TRANSMITTAL LETTER FOR THE RESPONSE TO NEW JERSEY DEPARTMENT OF
ENVIRONMENTAL PROTECTION COMMENTS ON FOCUSED INVESTIGATION AND
REMEDIAL ACTION WORK PLAN FOR BUILDING 556 NWS EARLE NJ

Subject: Response to NJDEP Comments
Focused Investigation and Remedial Action Work Plan for Building 566
Naval Weapons Station Earl, Colts Neck, New Jersey

GEOLOGIC CROSS SECTION MAPS FROM THE PHASE I RI REPORT

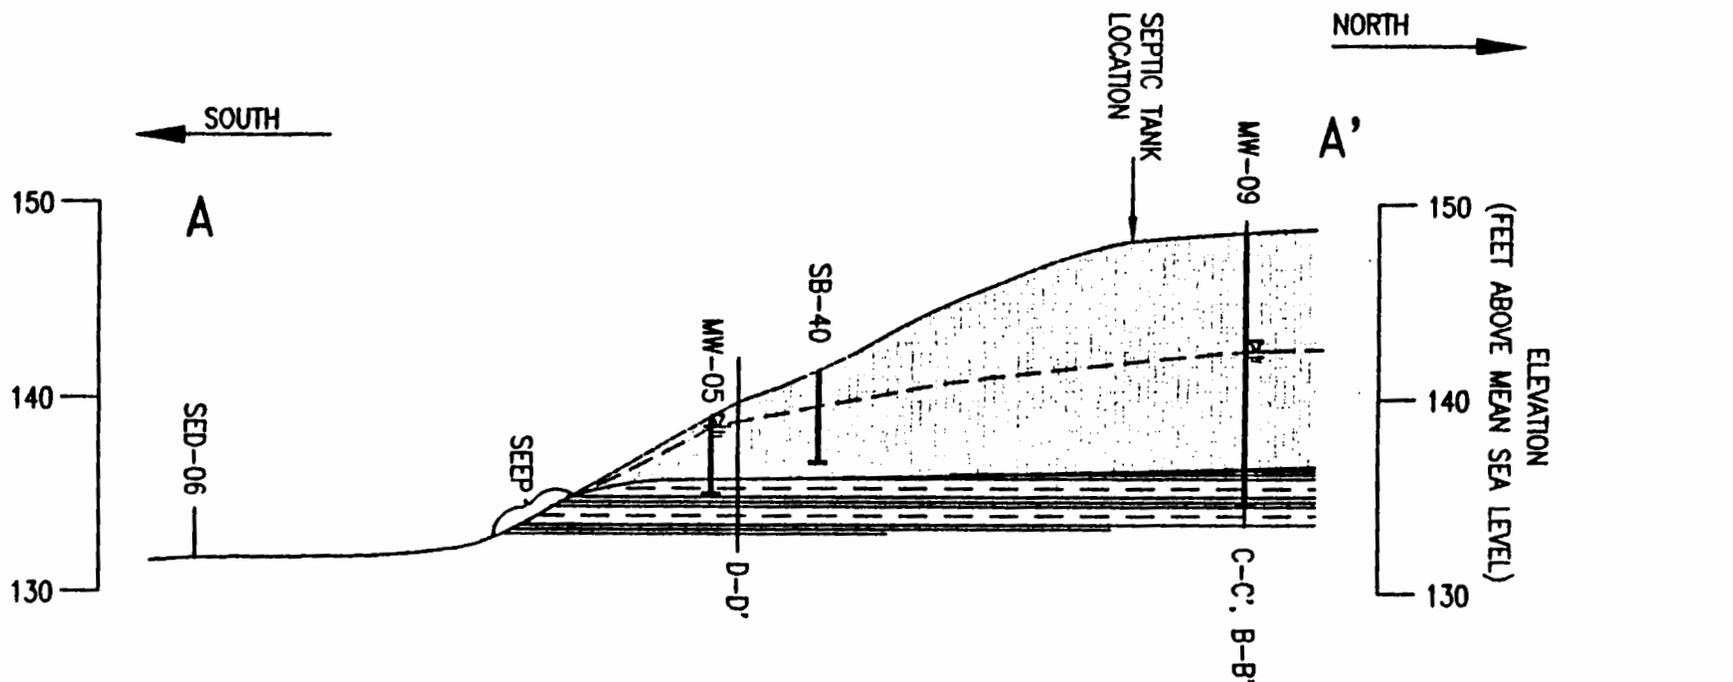
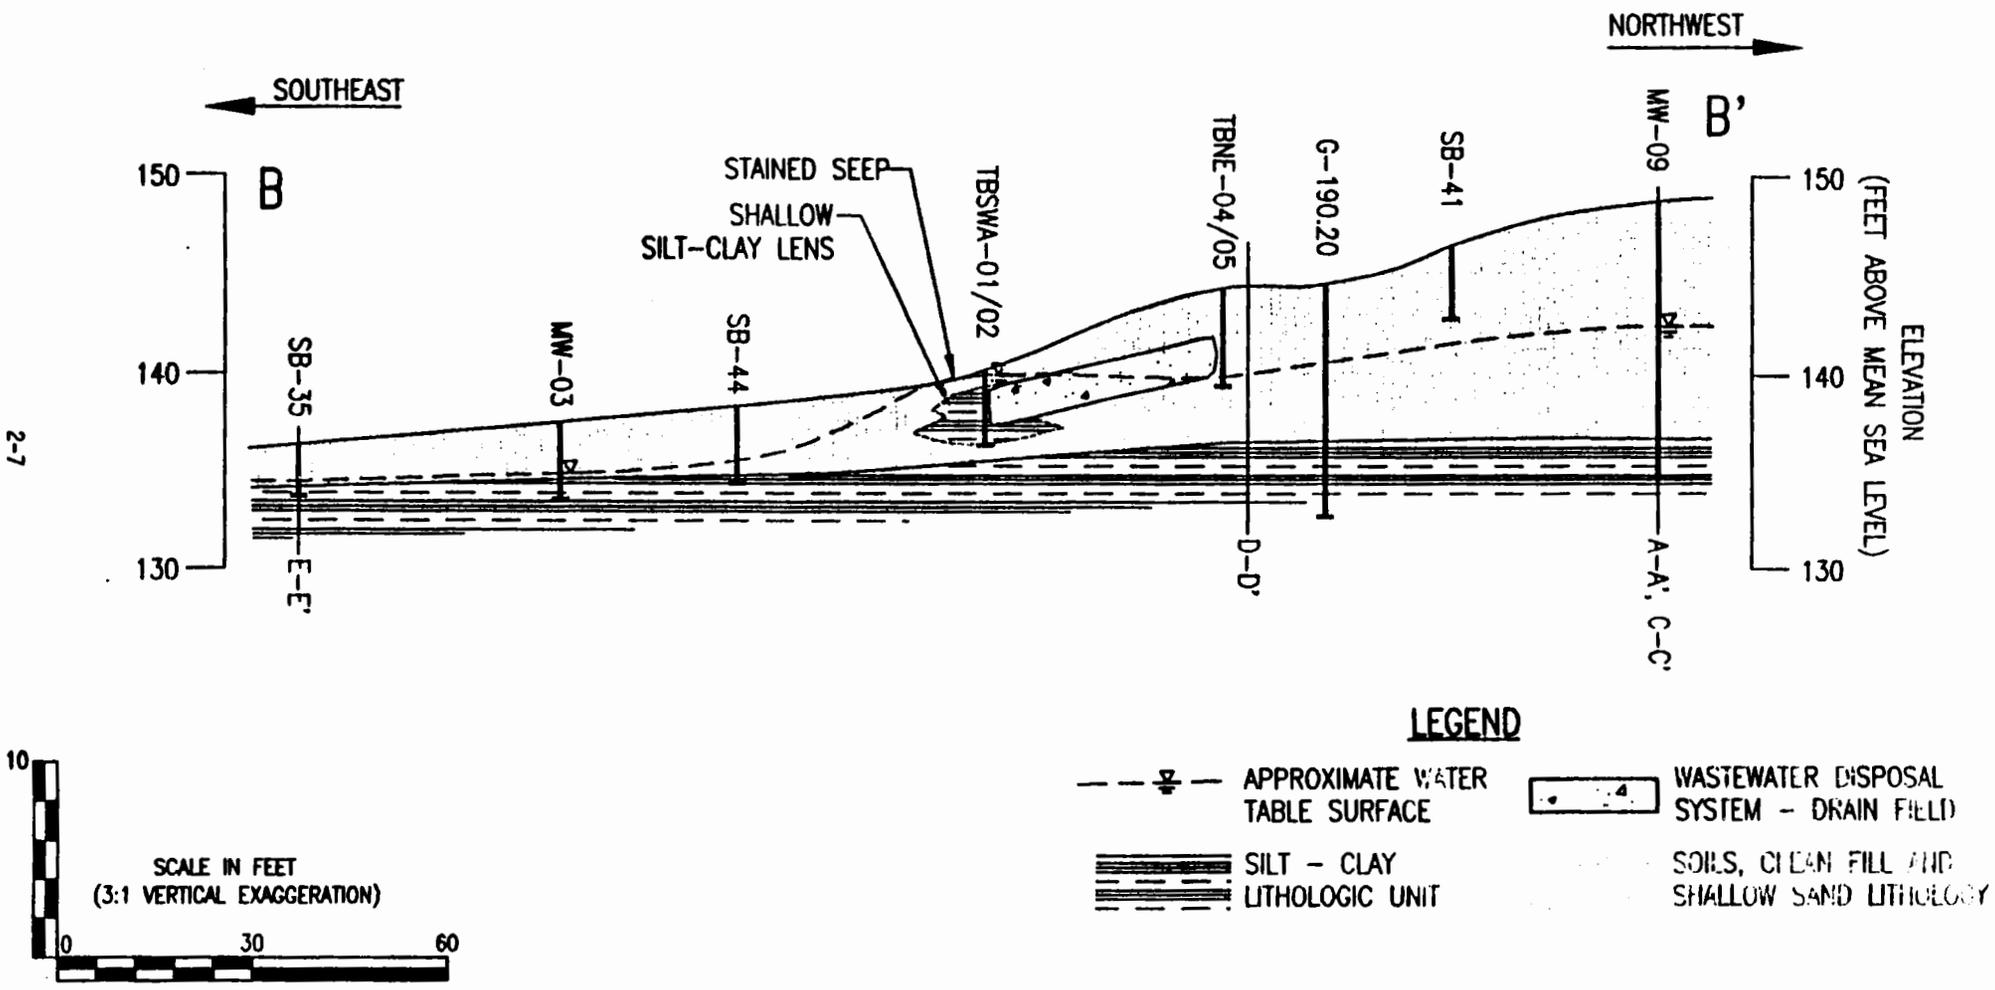
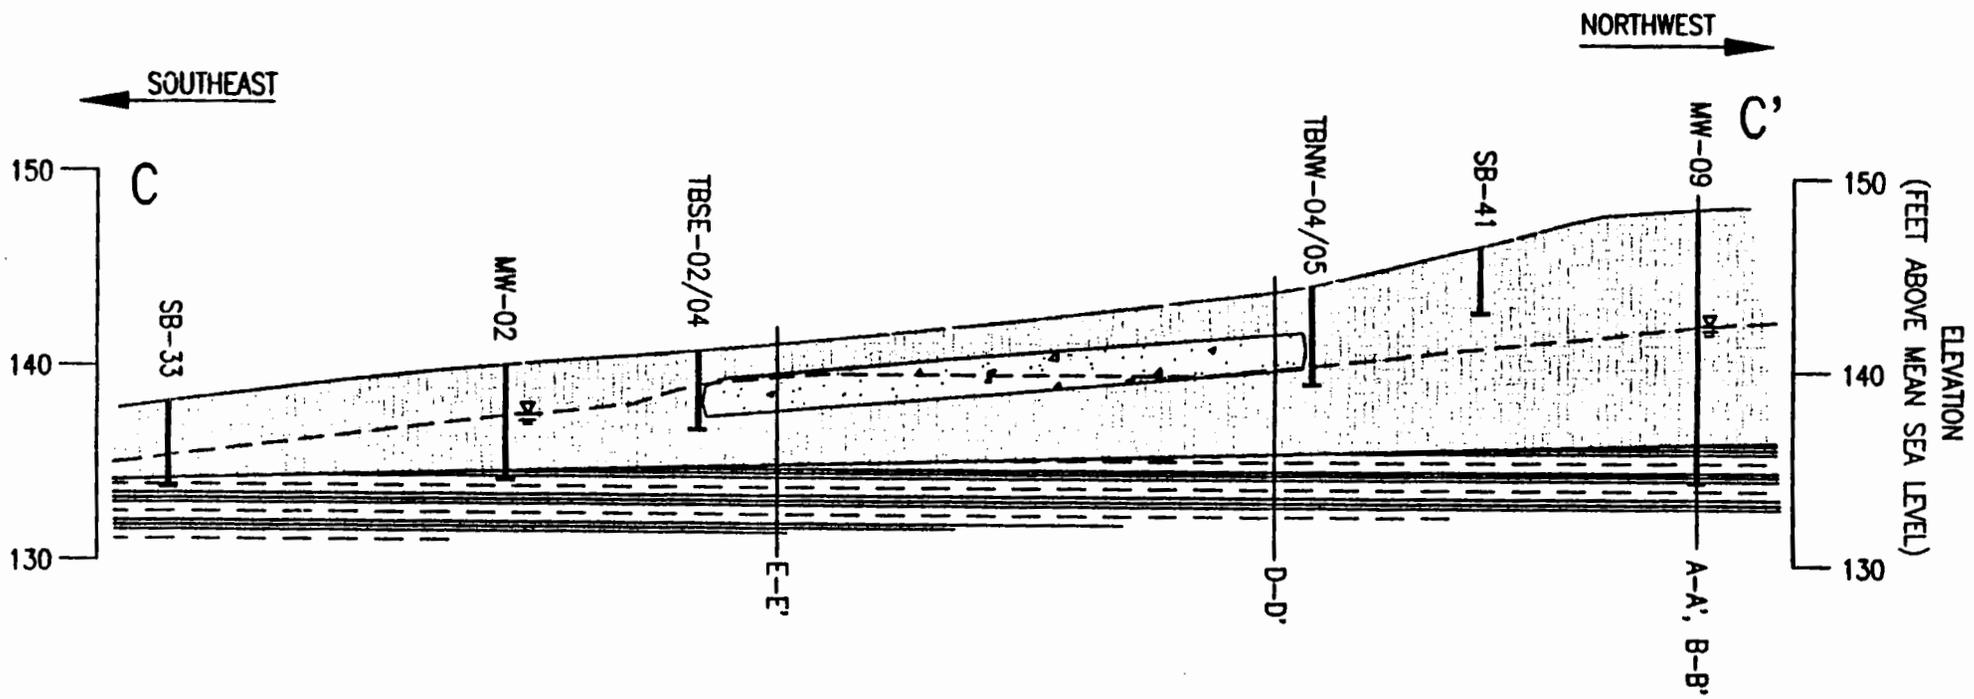
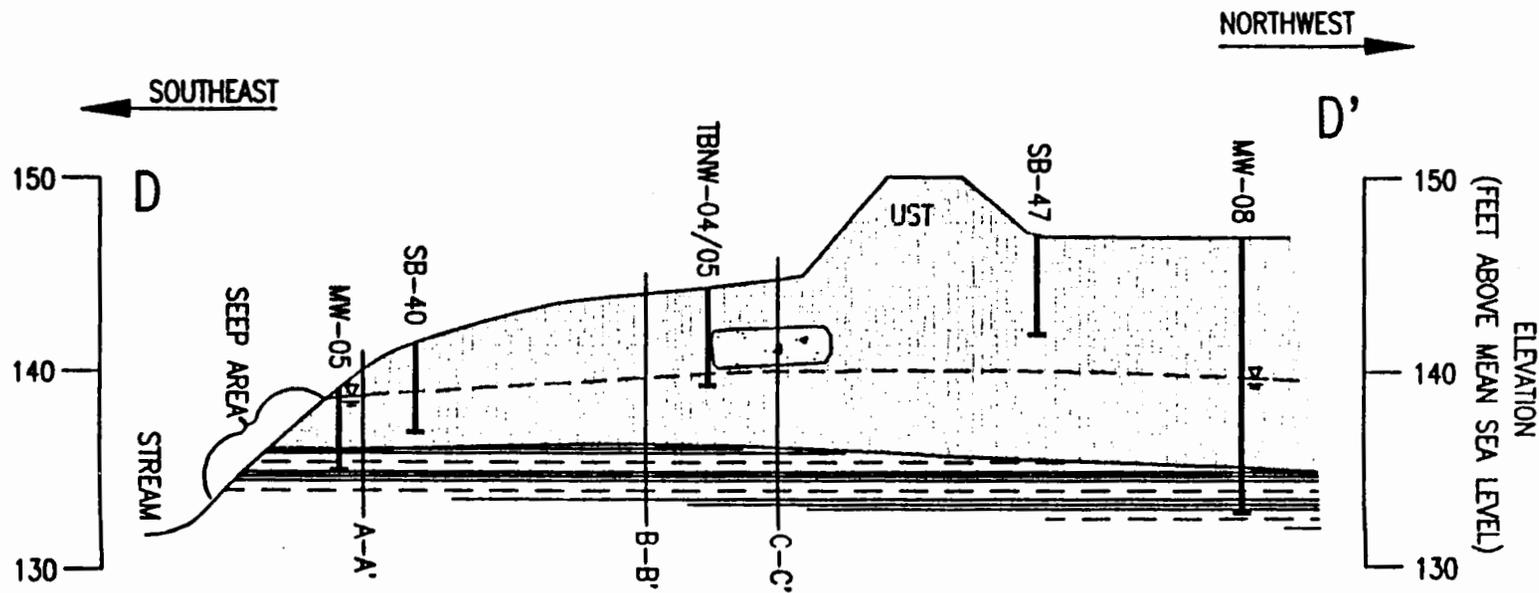
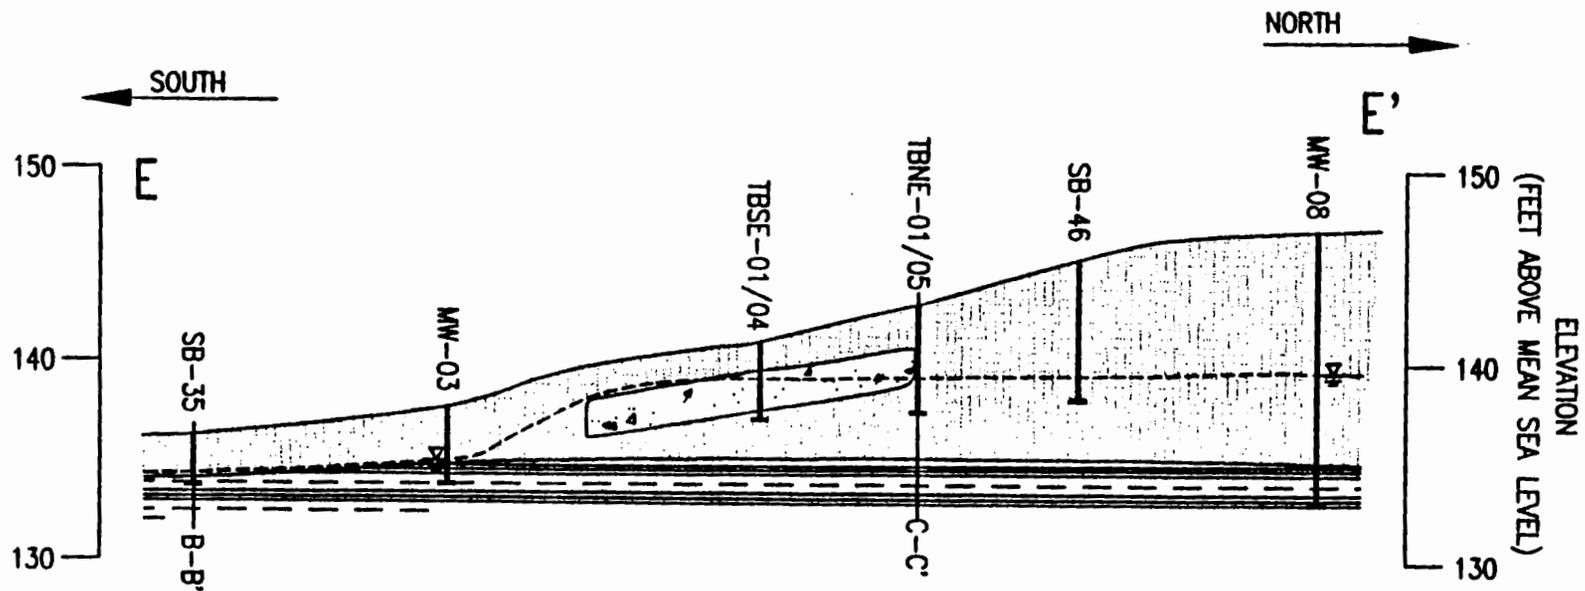
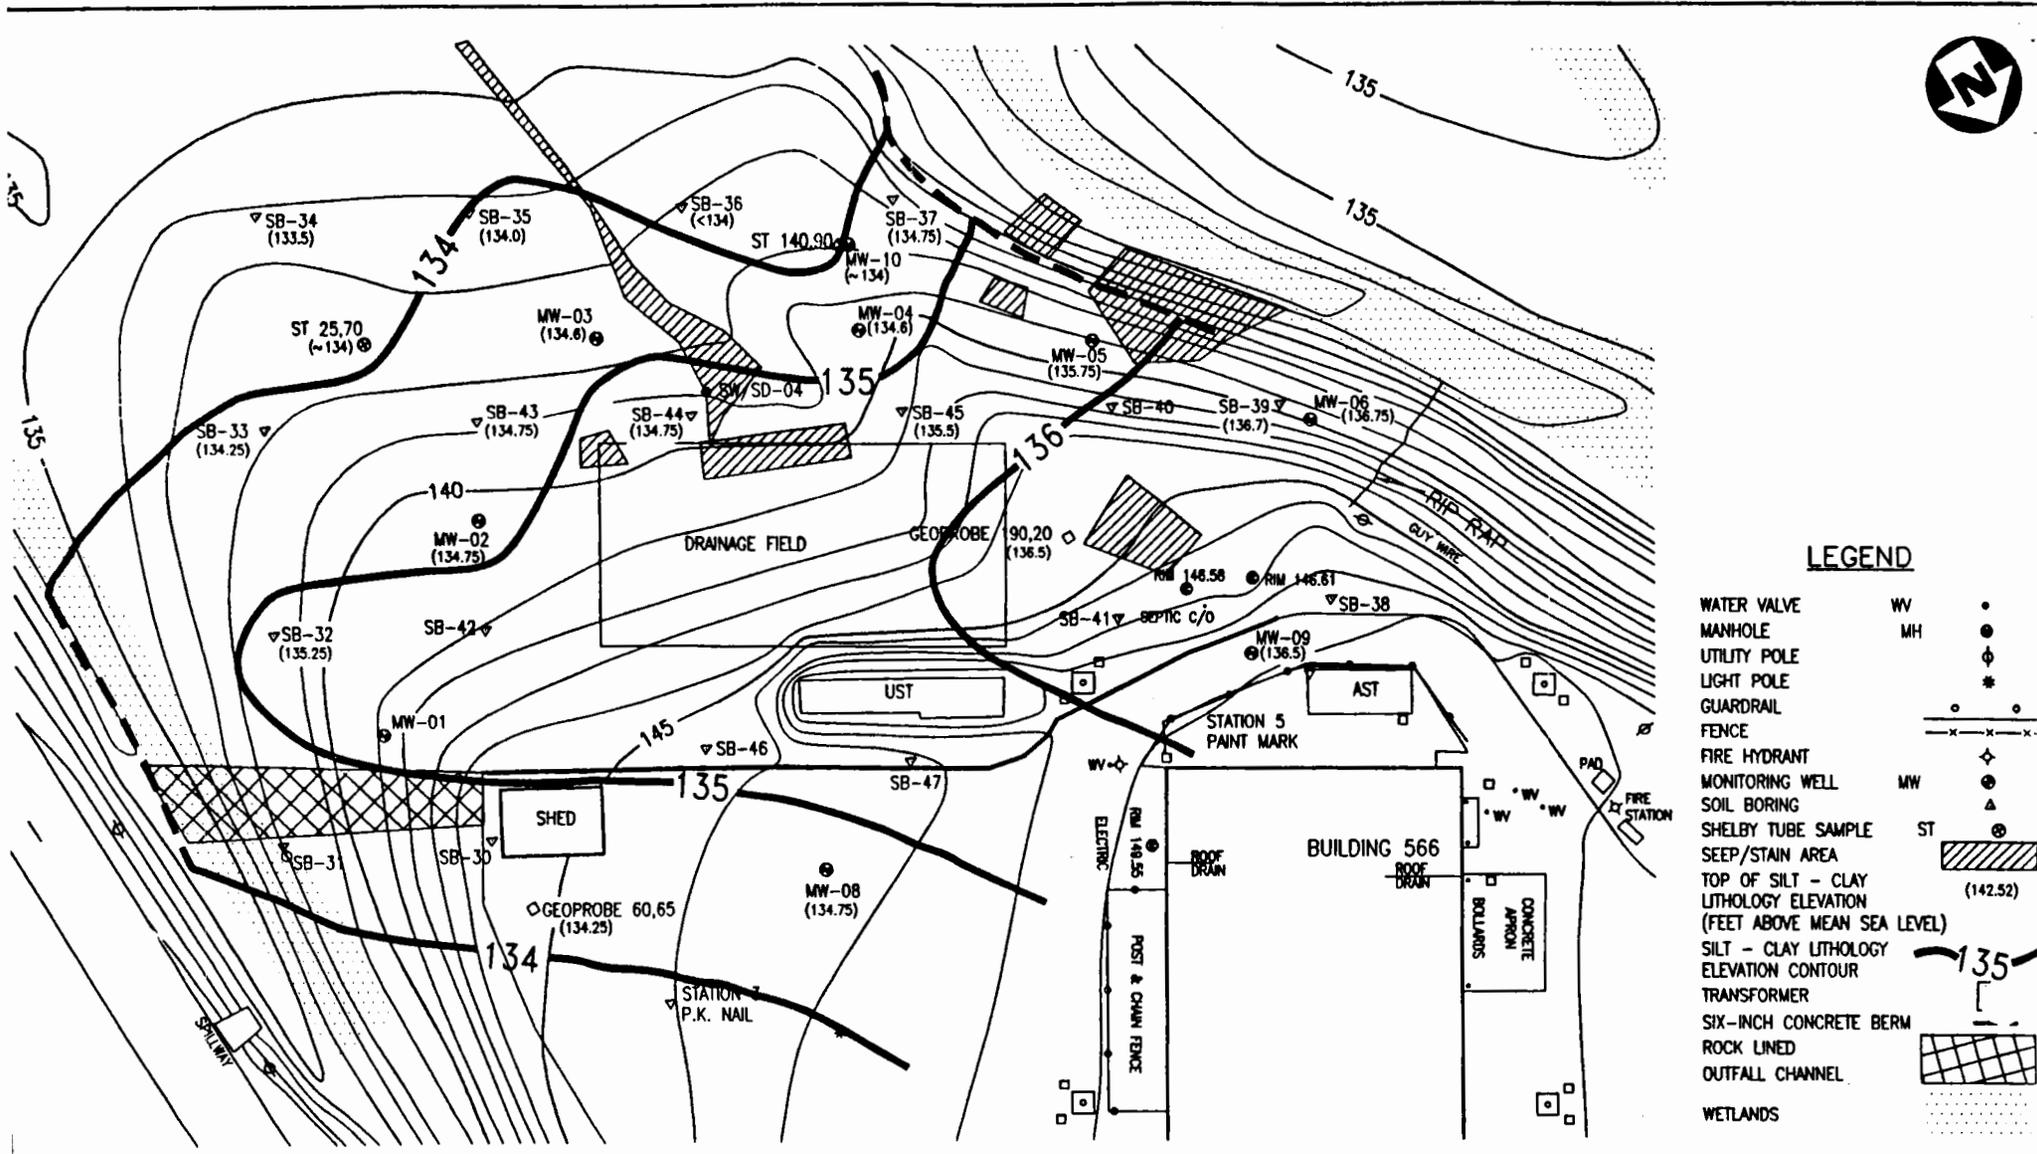
Comment 1: *Section 2.1, Results of Phase I RI, page 2-3: In the first paragraph on this page the contractor states, "The extent of the shallow ground water contamination is limited both horizontally and vertically by the silt-clay." This statement is incorrect. The silt-clay unit only prevents the contamination from migrating vertically, there is no horizontal component to prevent contaminant migration.*

It is correct that the silt-clay lithologic unit can only directly limit the vertical extent of shallow groundwater contamination. However, the presence of the silt-clay lithologic unit indirectly helps to limit the horizontal extent of shallow groundwater contamination by limiting the downgradient extent of the shallow aquifer.

The silt-clay lithologic unit acts as the confining layer for the bottom of the shallow aquifer. The land surface and the silt-clay lithologic unit both generally slope in a radial direction away from the site, in the same general direction of inferred groundwater flow. The top of the silt-clay lithologic unit slopes at a lesser gradient than the ground surface. The net effect of this is a gradual thinning of the shallow aquifer to the point where it is of negligible thickness. The groundwater either intersects the ground surface where it is discharged through seep areas, or is lost through the soil layer by evapotranspiration. These are the circumstances by which the horizontal extent of shallow groundwater contamination is limited. This hydrogeologic model is most clearly demonstrated by the geologic maps and cross-sections of the Phase I Remedial Investigation (RI) Report for Building 566 (Brown & Root Environmental, October, 1996). Copies of these figures are included with this letter in Attachment A. Refer also to the response to NJDEP's Comment 3 below.
